Everything is connected

PC29 should better explore and join the various dots

Climate Strategies
Architecture
Value Management

PC 29

Figure 3. Calculating allowable height

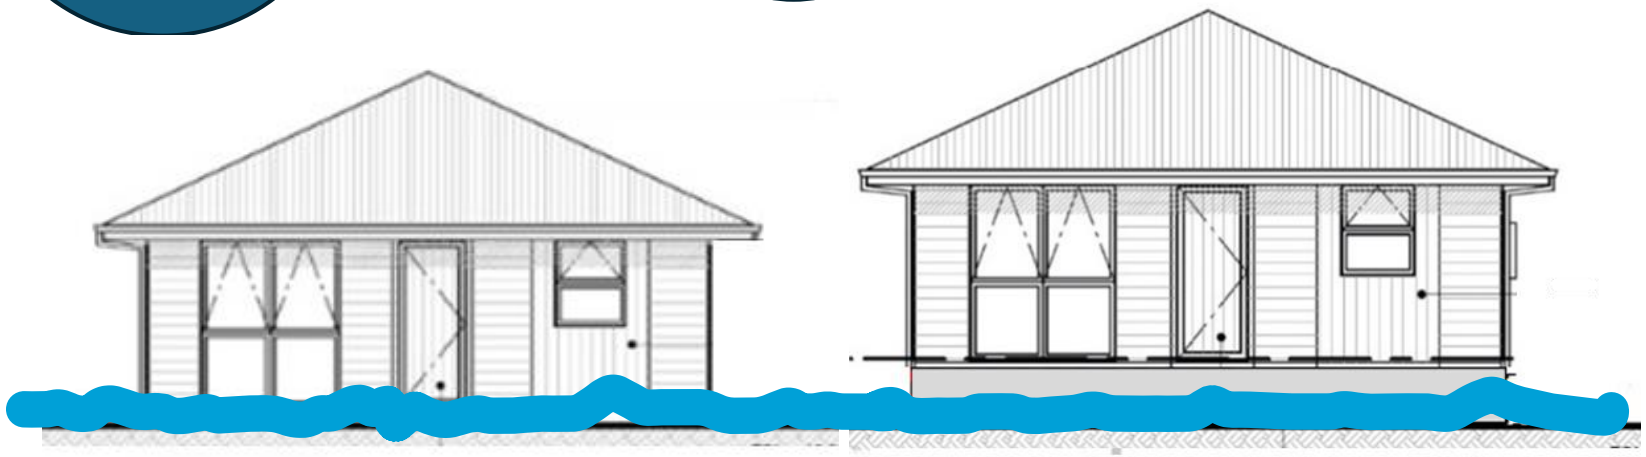
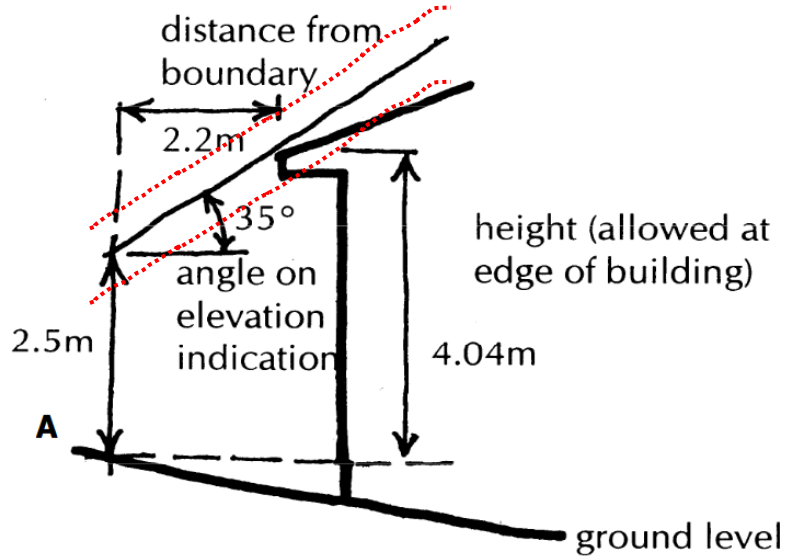
- Now most common
- FL 150 mm min above ground
- Easier access, more siteworks
- High emissions: conc. + steel
- Worse in flood or EQ
- Can't relocate
- Uses dwindling resources

- Traditional with crawl space
- FL say 800 mm above ground
- Low carbon, easier retrofit
- Renewable resources
- Flood freeboard, EQ resilient
- Mostly relocatable
- **Allow extra 600mm height for timber**

ADJUST NCC RMP TO ENCOURAGE TIMBER FLOORS

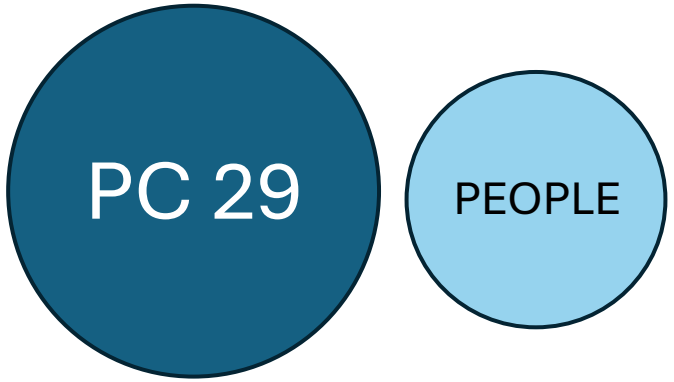
Can we build *and* be climate-safe?

WALK-UP HEIGHT
No lifts (lower cost and carbon, more resilient in AF8 or power loss)
Less overshadowing
Improved landscaping

TIMBER STRUCTURE
Local industry
Renewable
Low carbon
Quicker, lighter

HALF BASEMENT
Better flood protection
Great utility space
Improved privacy
Allow extra 1.2 m
